TOLEDO-LUCAS COUNTY PLAN COMMISSIONS

REF: SUP-7004-19

SUBJECT: Request for a Special Use Permit for a Day Care Center at 4311 Dahlia Drive

SITE PLAN
Scale: 1"=40'

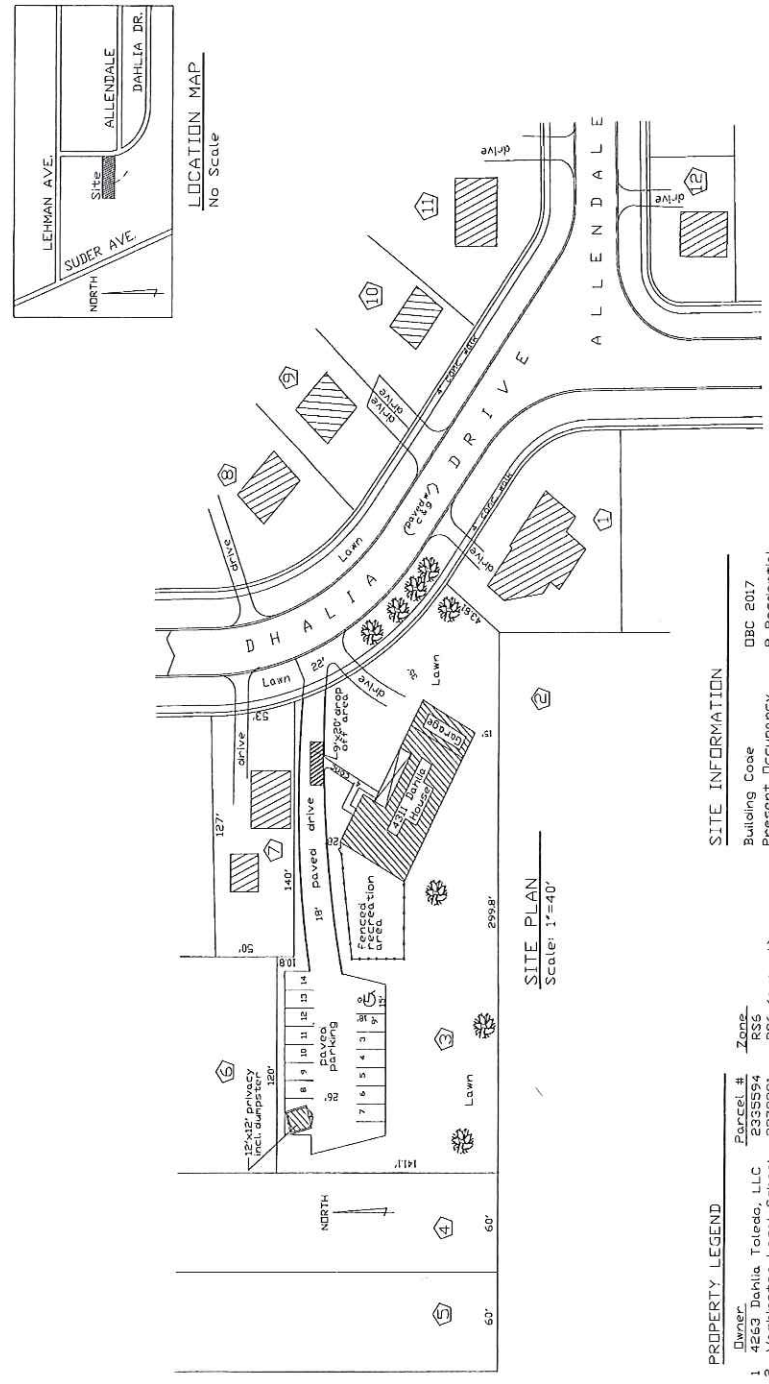
22. Thirty-five (35) square feet of useable indoor space per person in care must be regularly available for the day care operation. **Not acceptable as depicted on site plan. Usable indoor space shall be indicated on a revised site plan.**

25. Any spaces reserved for the use by persons with physical disabilities shall adhere to the standards outlined in TMC§1107.1700.
26. A minimum of two (2) bicycle parking slots shall be provided pursuant to Off-Street Parking Schedule "A" (TMC§1107.0300). **Not depicted on site plan. A revised site plan depicting the location and number of bicycle parking slots shall be submitted.**

- a. A Type "B" Landscape Buffer, which shall be a minimum of ten feet (10') in width with six (6) trees and either fencing or shrubs. The location, height and materials for any fencing to be installed and maintained shall be indicated; **not acceptable as depicted on site plan. Trees and fencing material shall be noted on a revised site plan.**

- f. Dumpster location(s) shall be clearly defined, have a concrete pad and be surrounded by a solid wooden fence or a masonry screen enclosure with landscaping and shall not be located in any required setbacks or the public right-of-way as stated in TMC§1361.10(b)(10) of the Building Code; **not acceptable as depicted on site plan. Screening materials shall be indicated on a revised site plan.**

LEHMAN AVENUE SUBDIVISION

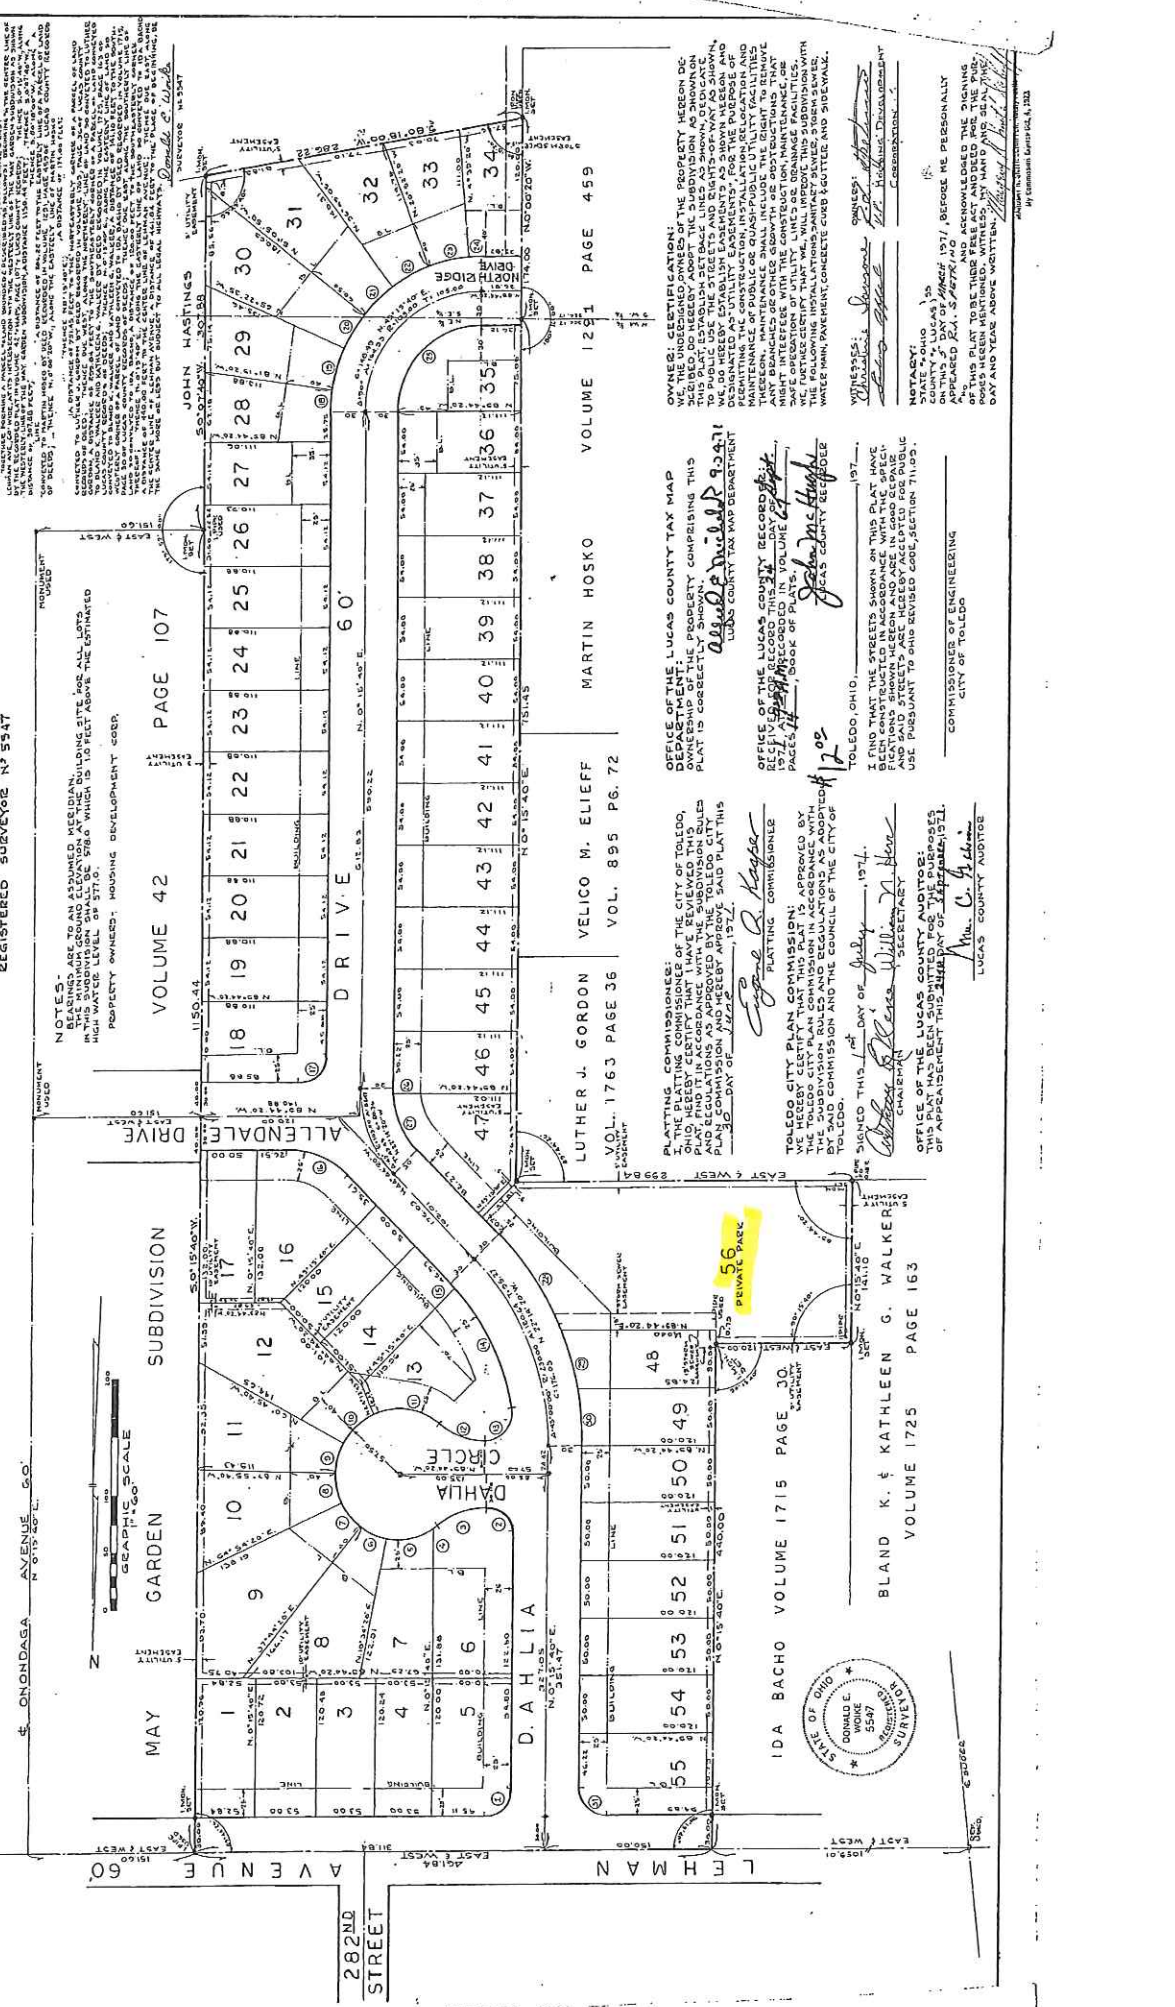
21. The Lehman Avenue Subdivision Plat identifies the property as a "Private Park". A single lot replat is required in order to change the use. **This is a subdivision regulation and is not subject to waiver procedures.**
